NUCLEAR REACTOR LABORATORY
AN INTERDEPARTMENTAL CENTER OF
MASSACHUSETTS INSTITUTE OF TECHNOLOGY

Subject: Response to Request for Additional Information for the License Amendment Request to Upgrade the Nuclear Safety System at the MIT Reactor, License R-37, Docket No. 50-20 (CAC No. MF5003)

The Massachusetts Institute of Technology (MIT) hereby submits a response to the Request for Additional Information (RAI) on the License Amendment Request (LAR) to upgrade the Nuclear Safety System at the MIT Reactor (MITR). The RAI was created on 12 October 2017 subsequent to a regulatory audit that was performed by Nuclear Regulatory Commission (NRC) staff at the MIT Reactor on 24-26 July 2017. This audit identified additional information that would be required to be docketed in order to support a licensing decision by NRC.

DRAWN KOUTIRON	DATE 11/17/17	SIZE B	FILE NO. QA# 2017-34	DWG NO. R3W-268-2	REV
REVIEWED & APPROVED SH/PM	12/1/17	SCALE NONE		SHEET 1 OF 1	
DESIGN KOUTIRON	4/10/17

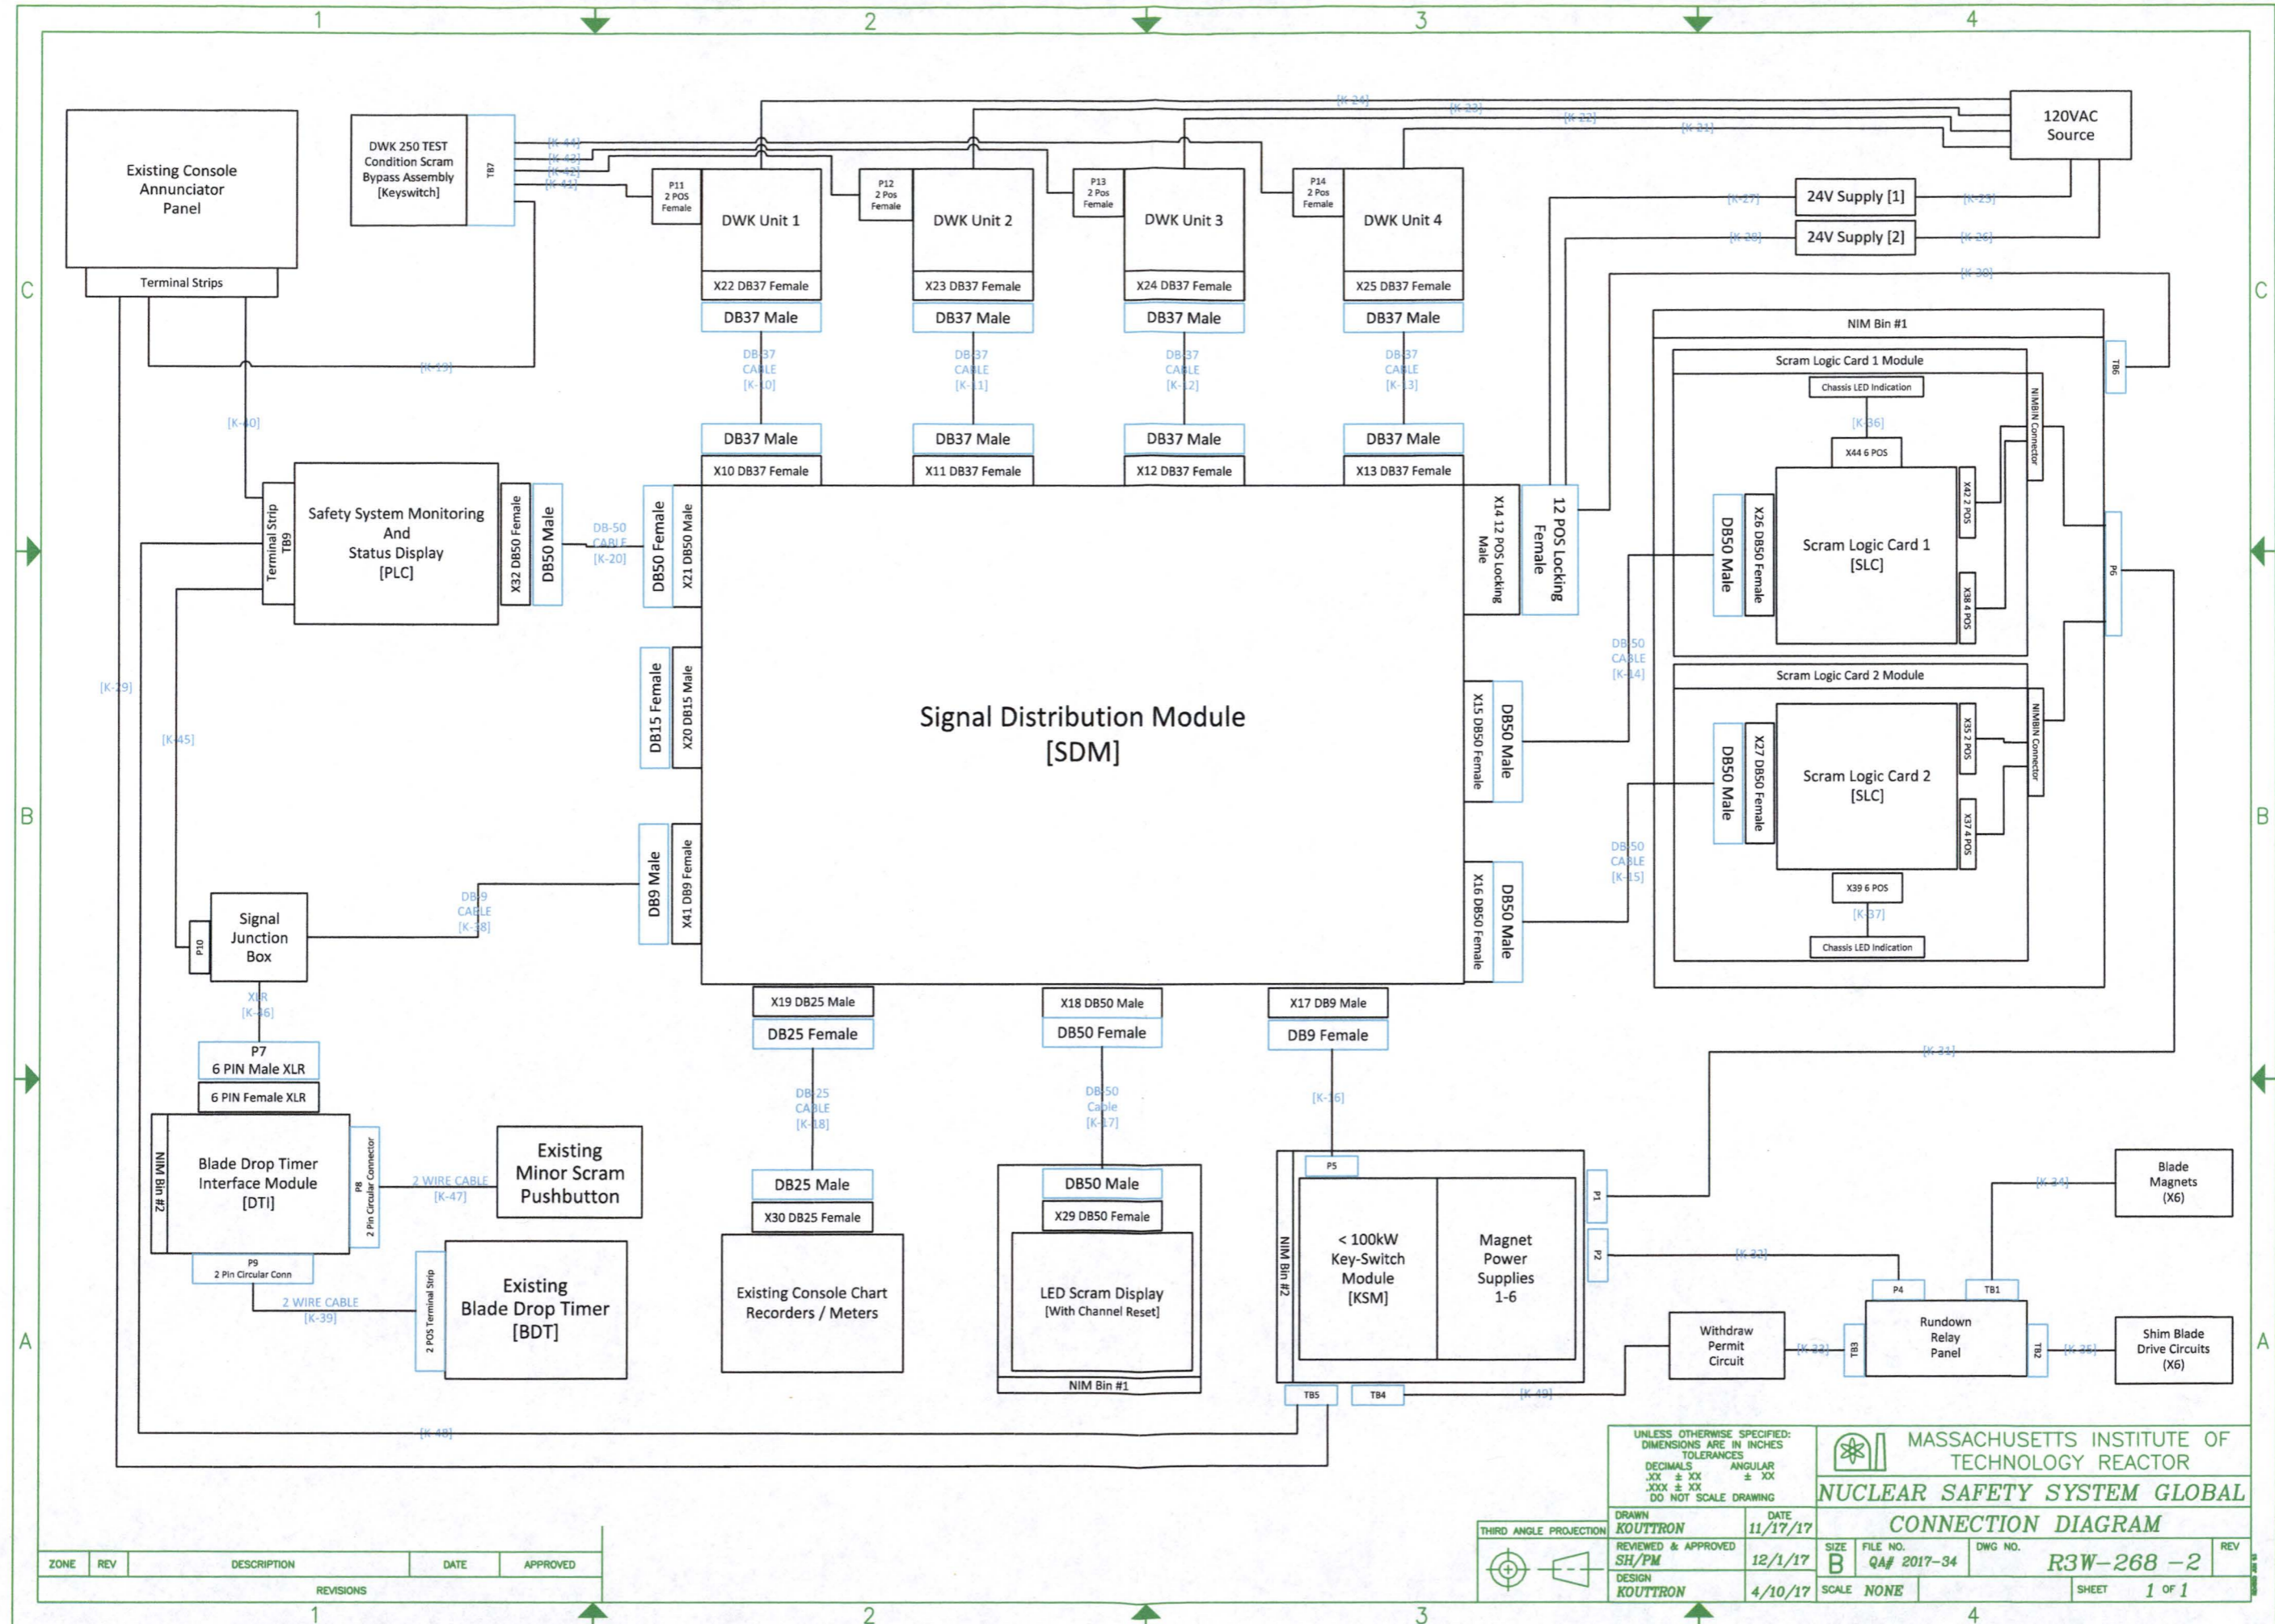
- c) *Drawing R3W-256-2, DWK Safety System Global Connection Diagram, does not show all connections to the NSS components. For example Revision 1.6 does not include the following connections: (1) between Signal Distribution Module (SDM) and the PLC and (2) KSM to PLC.*

Drawing R3W-256-2 "DWK Safety System Global Connection Diagram" has been superseded by Drawing R3W-268-2 "Nuclear Safety System Global Connection Diagram".

An updated Drawing R3W-268-2 "Nuclear Safety System Global Connection Diagram" has been provided in Enclosure D. This update incorporates the connection between the SDM and the PLC and the connection between the KSM and the PLC.
